BOARD OF ADJUSTMENT AGENDA ITEM

SUBJECT: **Higgins Variance Request (VAR-2016-01)**

BOARD OF ADJUSTMENT AGENDA ITEM

SUBJECT: WoodSpring Suites Hotel and Detached Restaurant – 4650 W. New Haven Avenue Conditional Use (CUP-2016-02)

Attachment 2

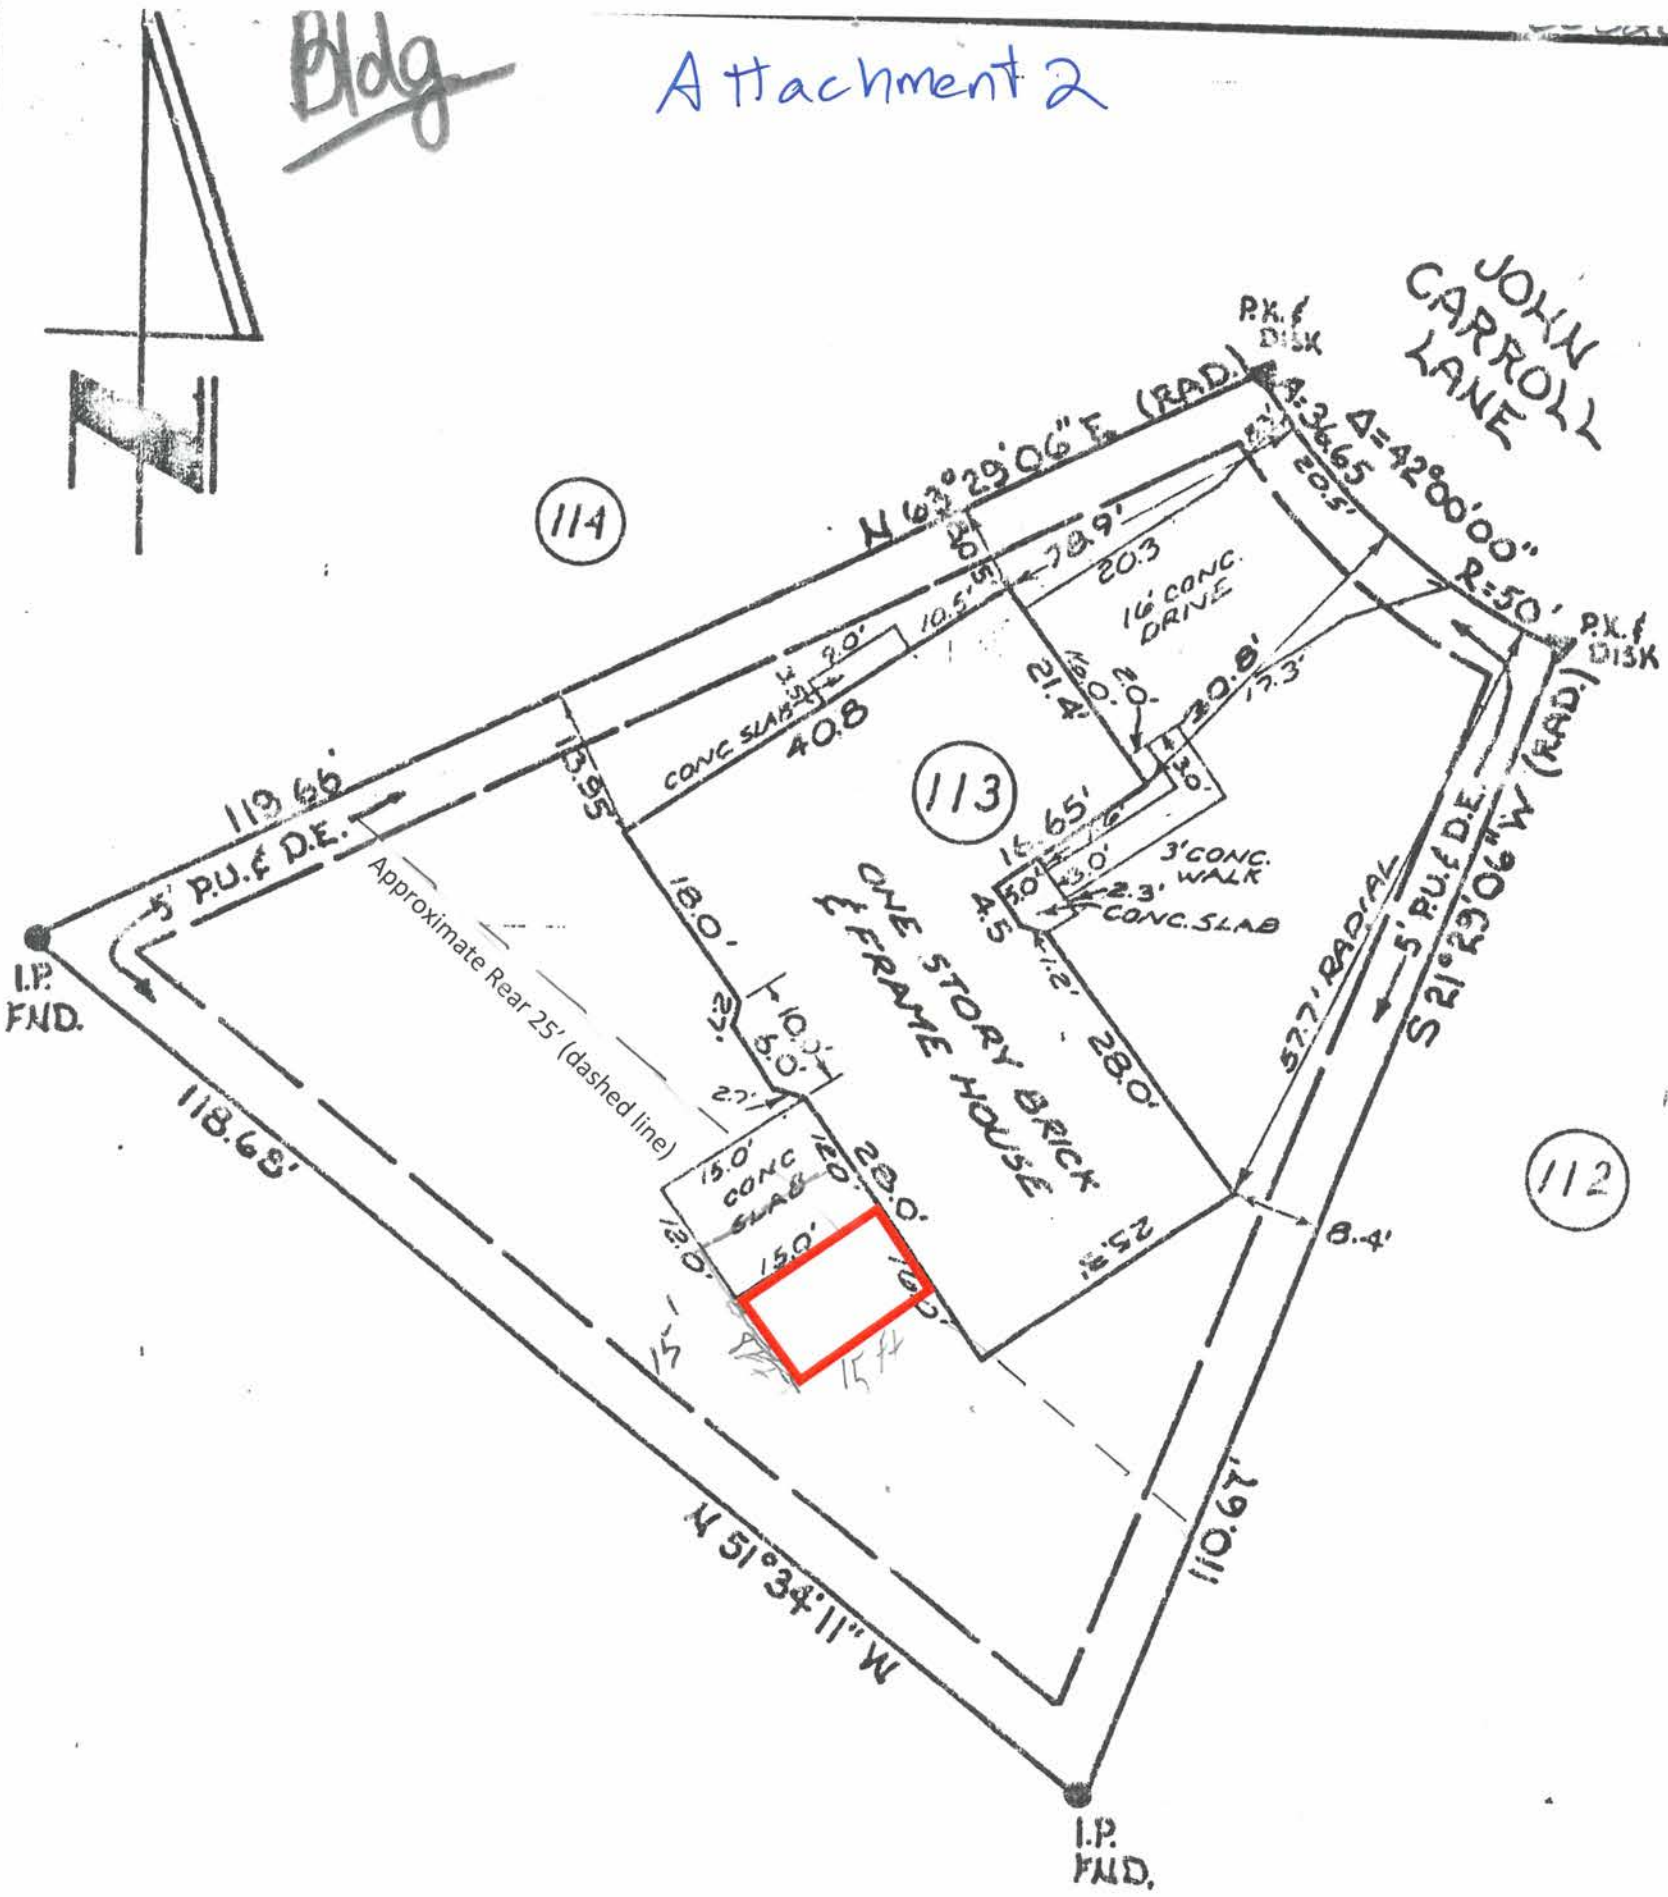
Staff Comment: The special circumstances of the pie shaped lot were not caused by the applicant's actions. If one looks closely at Attachment 2, it appears that the front of the house may not comply with the front 25' setback either and that the house could have been pushed into the rear yard setback if the house were truly centered and parallel to the angle of the side, front and rear property lines. However, since no expansion is being proposed to the front, the only subject of this variance request is to the rear property line.

1. If the structure depicted in Attachment 2 (20 feet x 15 feet) is destroyed, only a structure similar in size and in the same location and orientation, or with less impact, will be allowed to be rebuilt under the variance approval. If a larger structure is proposed, the applicant must submit and obtain another variance.

LANDSCAPE PLAN

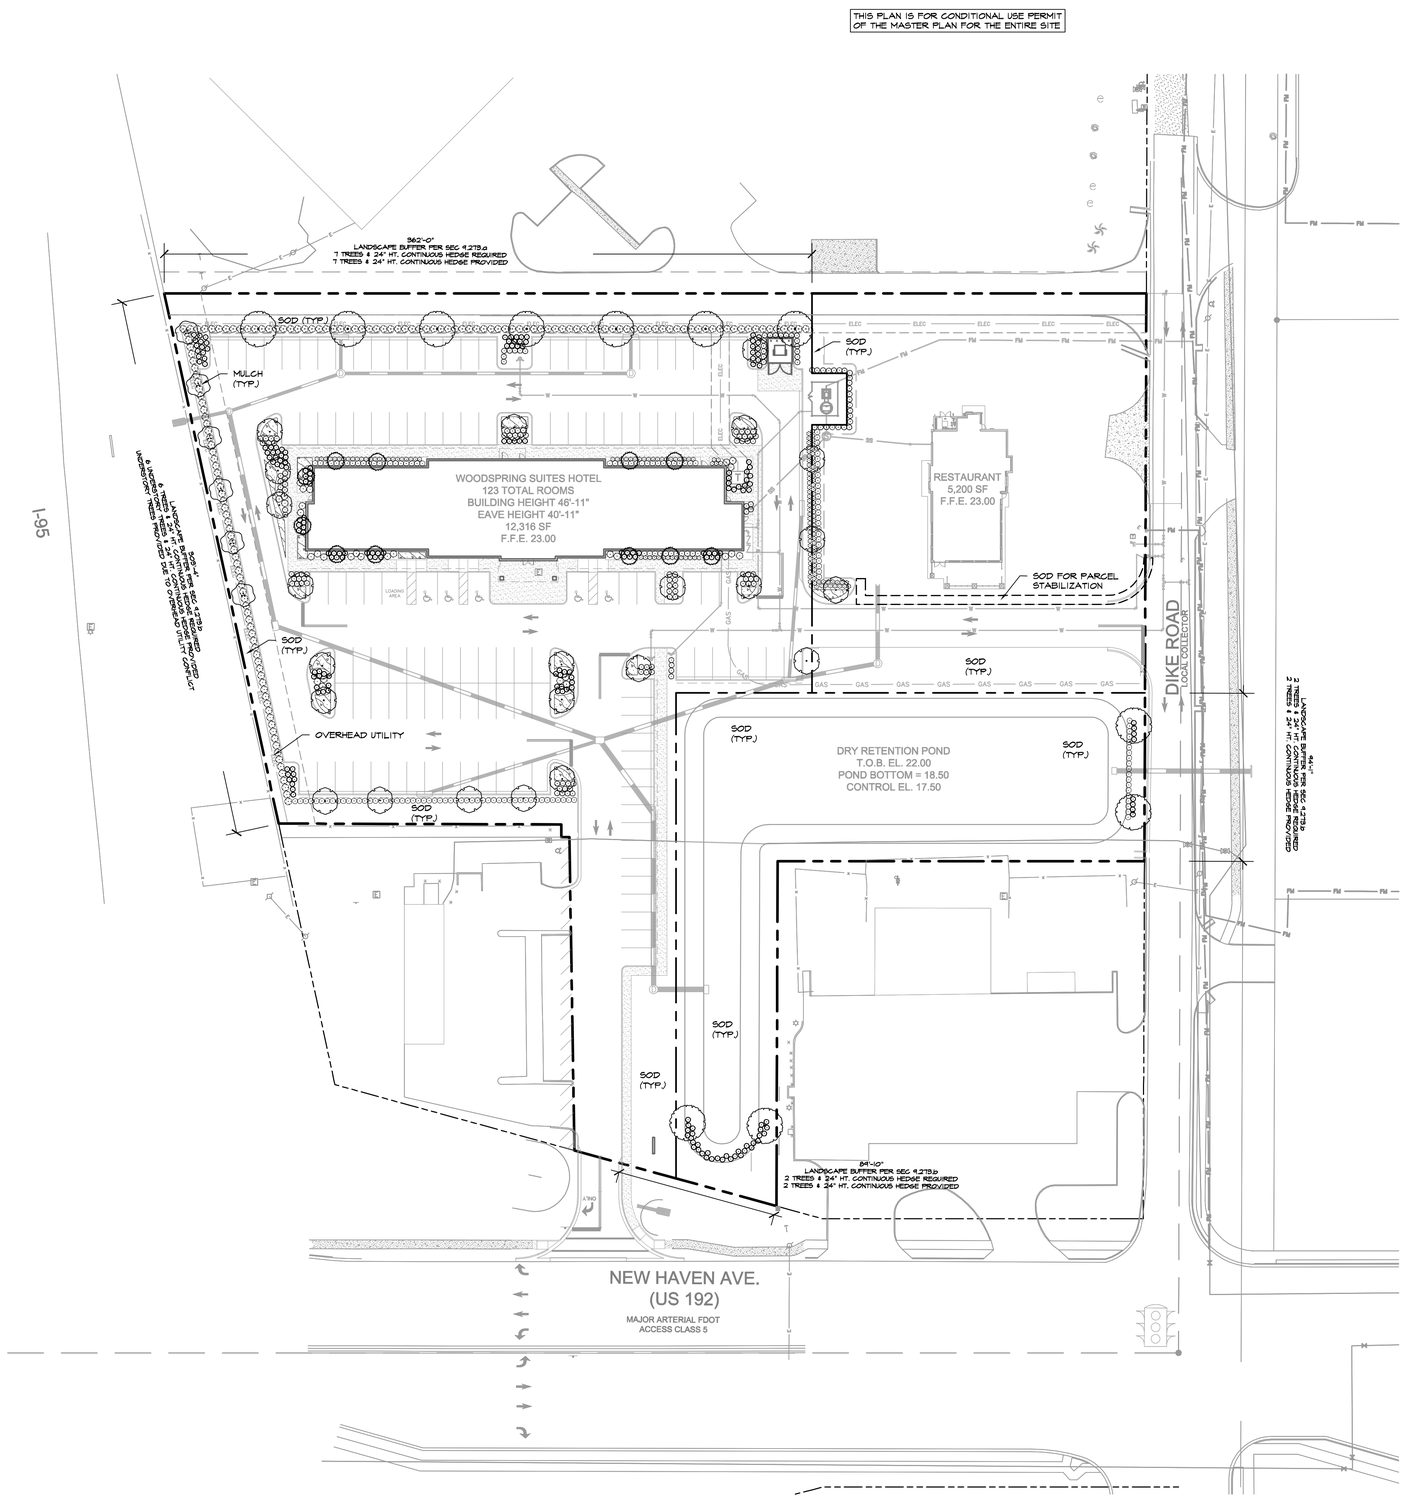
3. *Solid Waste and Service Areas* – A dumpster is proposed behind the building, located on the northeastern corner of the parking lot and will be shielded from view by a wall and hedges, which are both required. Staff will require the hedge line to be 6' tall immediately upon planting for both the dumpster and the lift station. The applicant

submitted the attached landscape plan which is not clear about the height of the shrubs around the utility facility and the dumpster.
